CEMVN-CD-NO-Q

18 September 2000

SUBJECT: Contract No. DACW29-99-C-0005, Lake Pontchartrain, Louisiana and Vicinity, London Avenue Outfall Canal, Parallel Protection, Floodproofing of Gentilly Boulevard Bridge, Orleans Parish, Louisiana

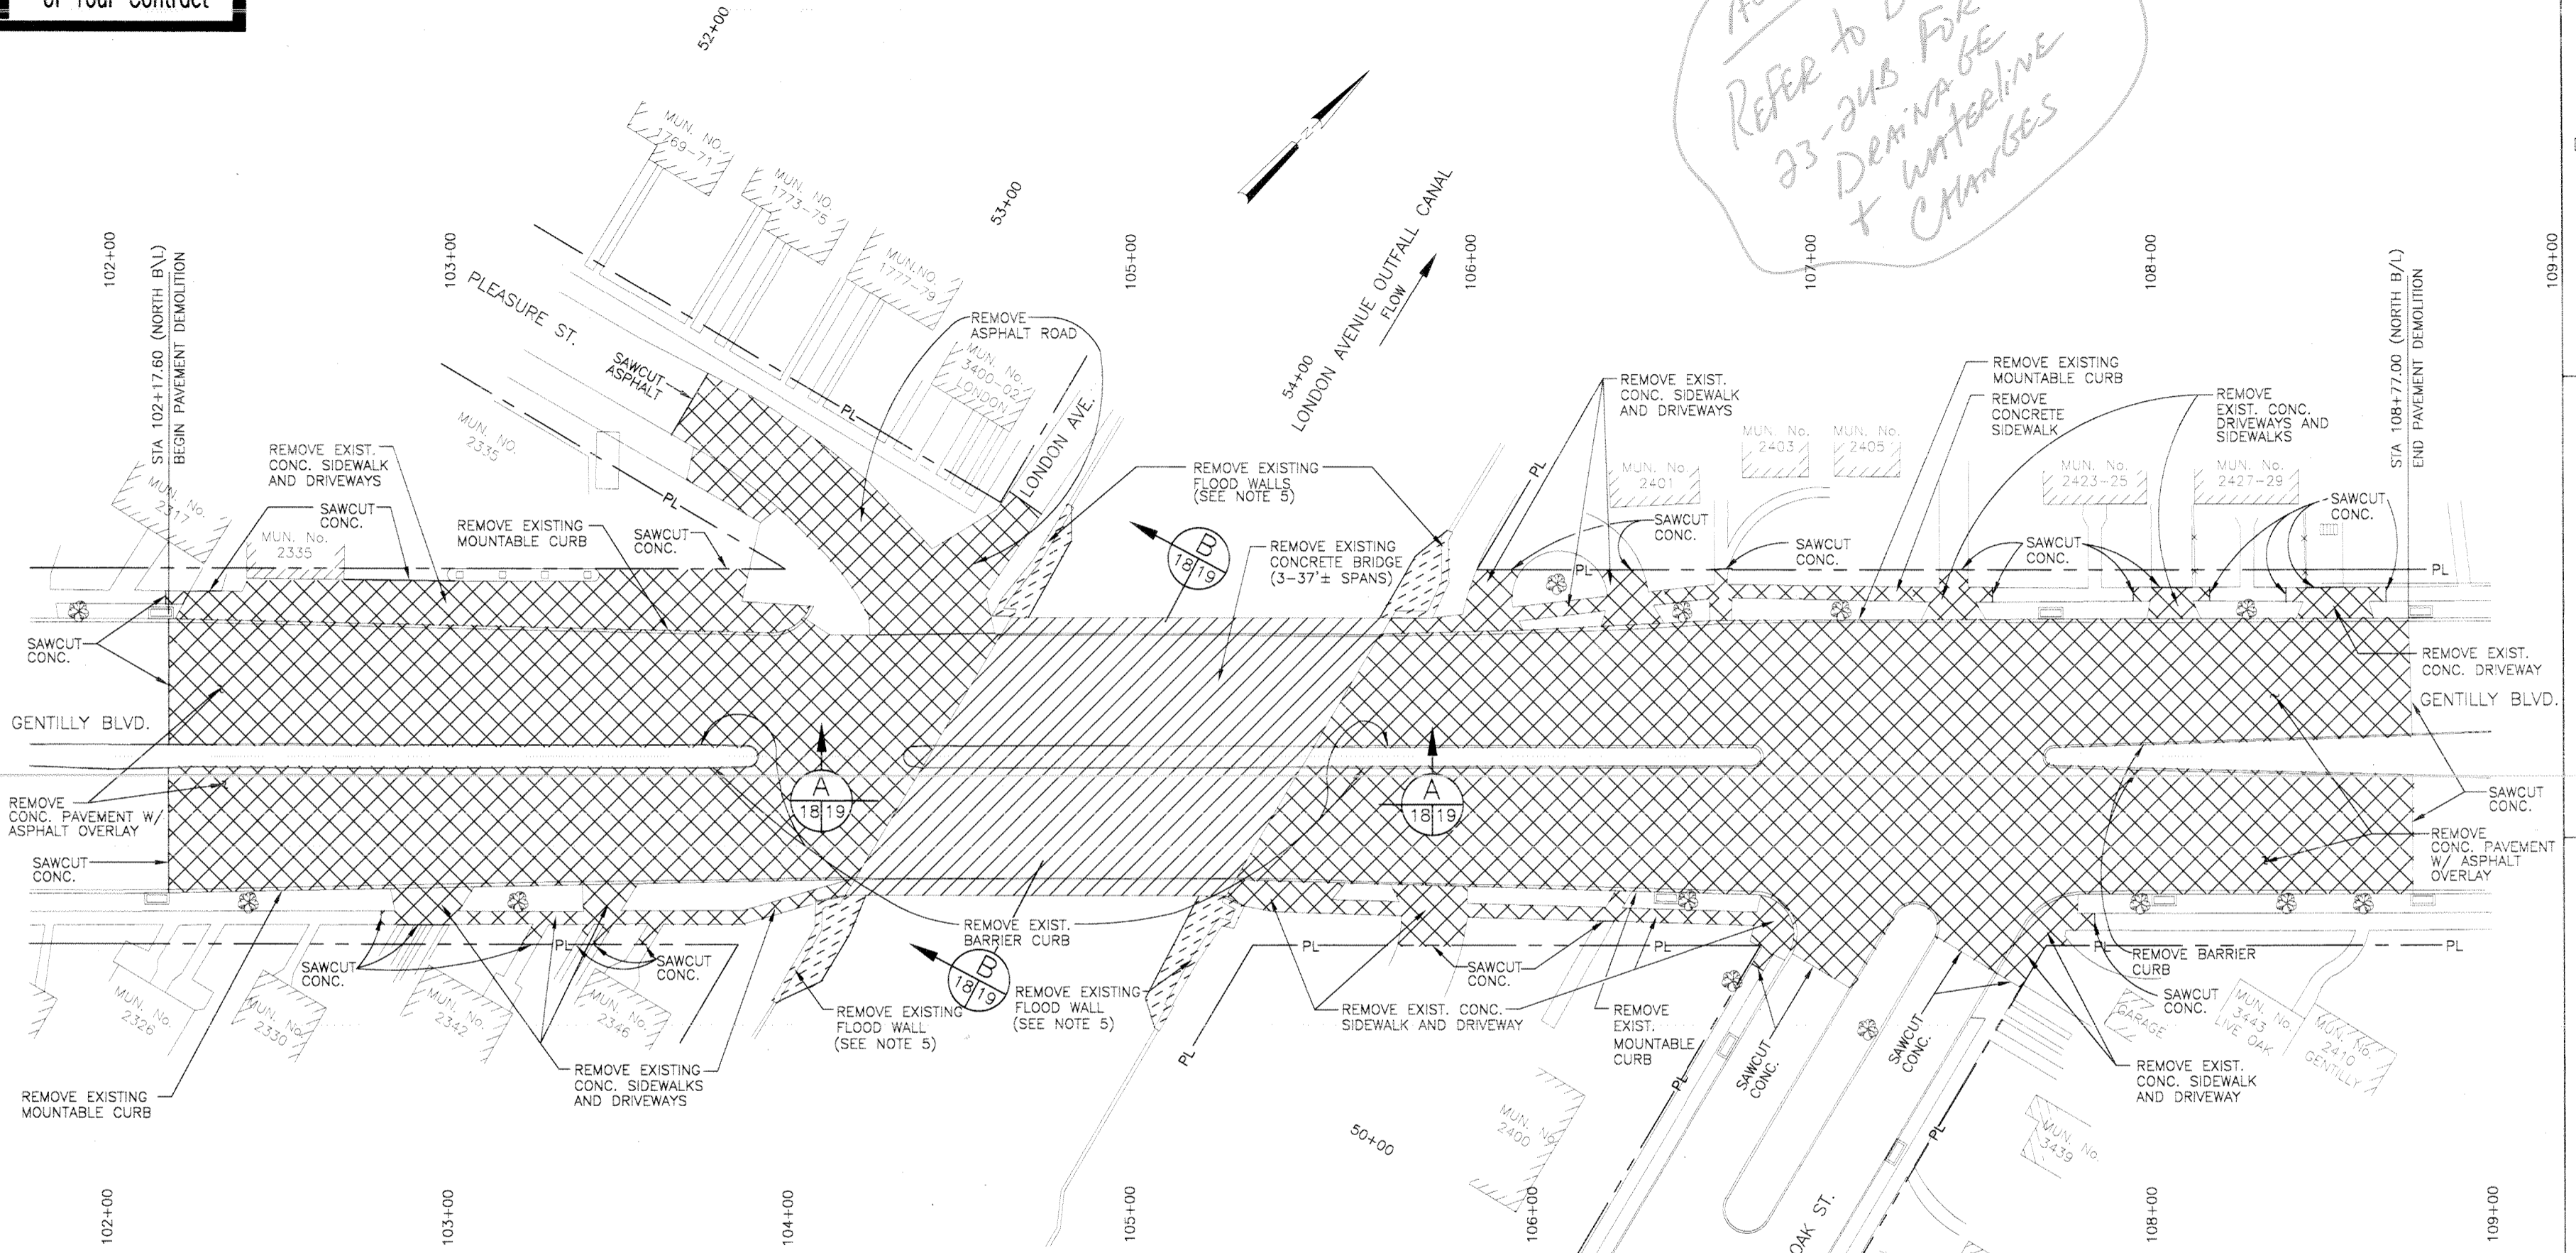
A00004
REFER TO DWG
23-248 FOR
DEMINGUE
+ WATERLINE
CHANGES

GENTILLY BLVD. BRIDGE
 CAST-IN-PLACE REPLACEMENT GIRDER
 DRAWN BY: []
 CHECKED BY: []
 IN CHARGE: []
 DATE: 5/15/00
 SHEET: S-1
 OF 2 SHEETS

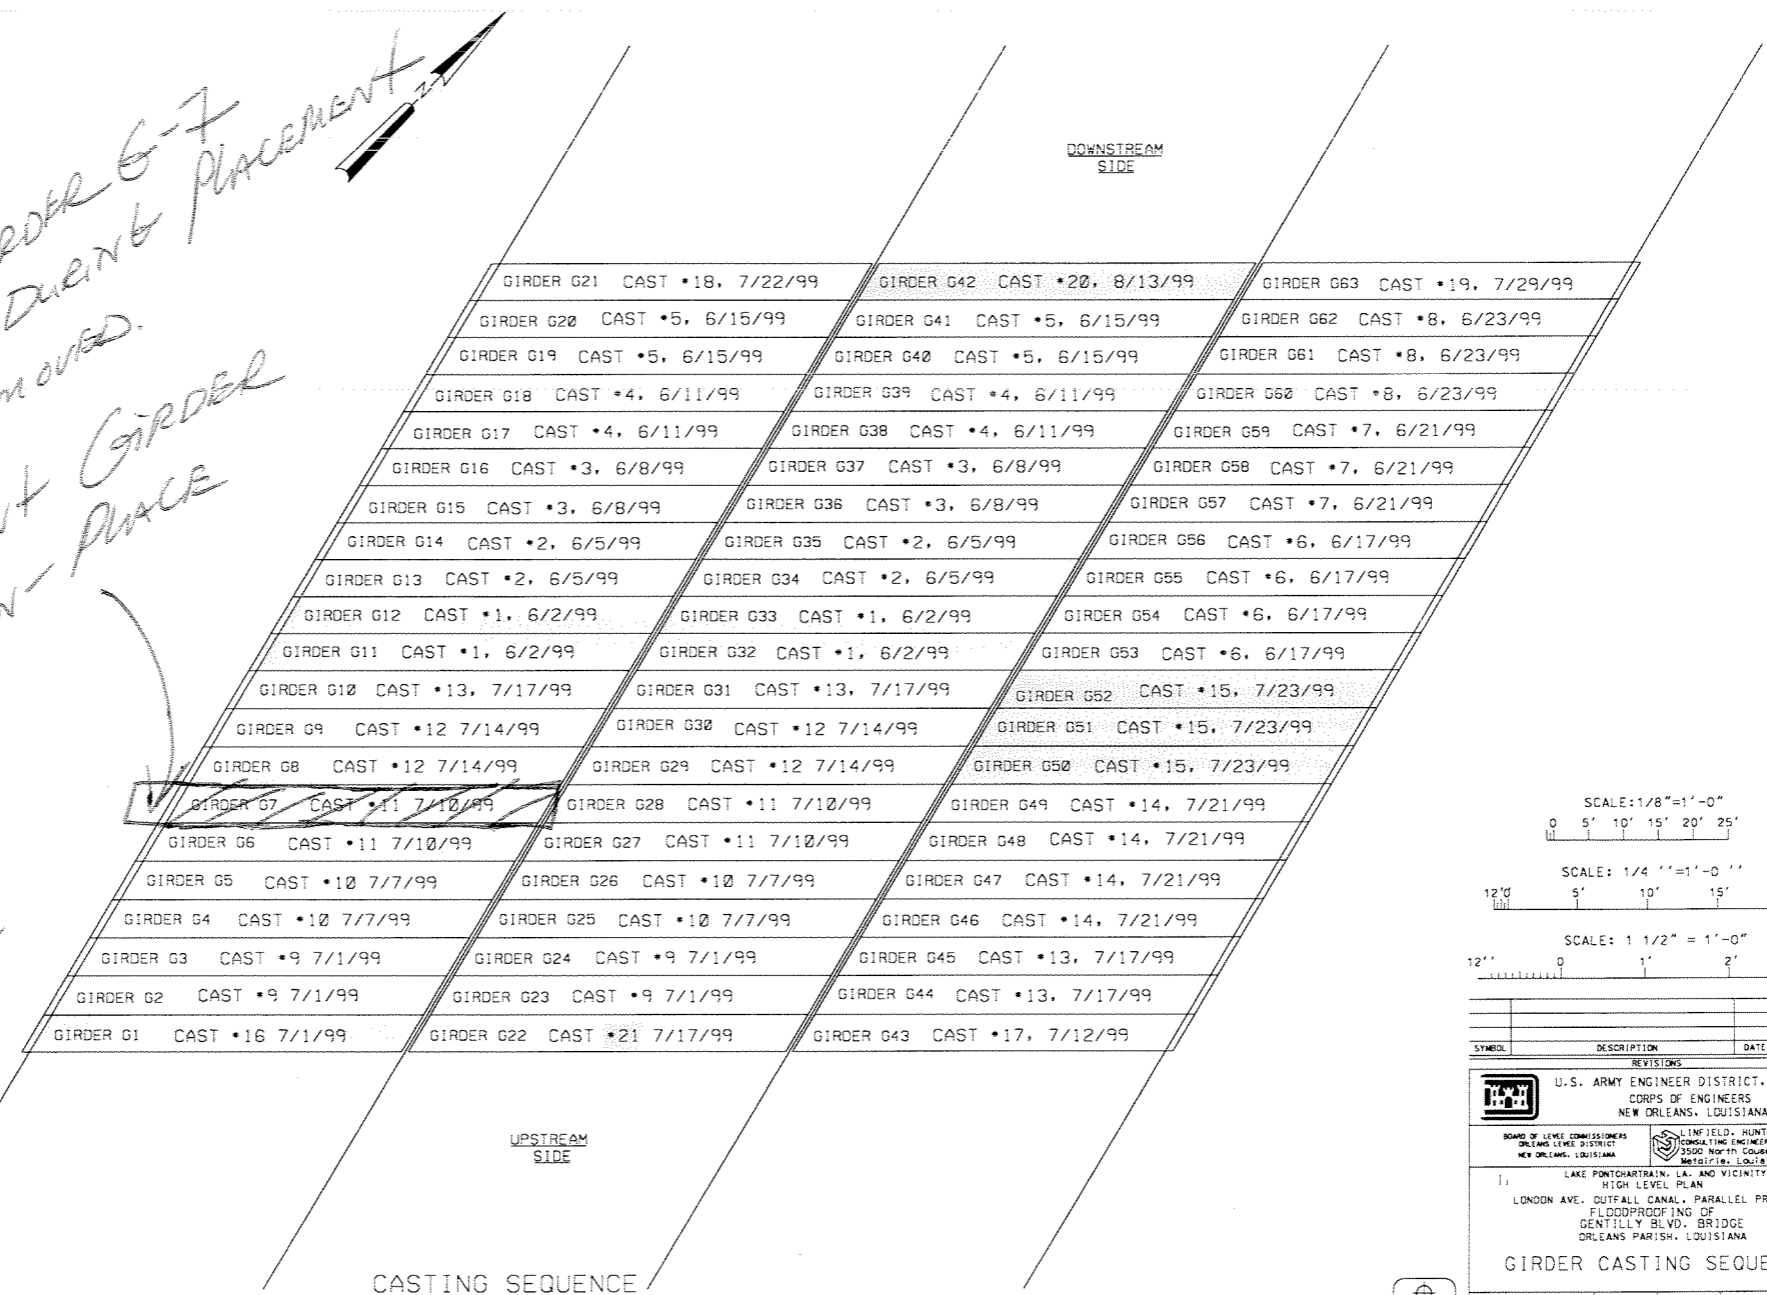
*PRECAST GIRDER 6-7
DAMAGED DURING PLACEMENT
AND REMOVED.
REPLACEMENT GIRDER
CAST-IN-PLACE*

** SEE ATTACHED
DETAIL OF
C-I-P MEMBER*
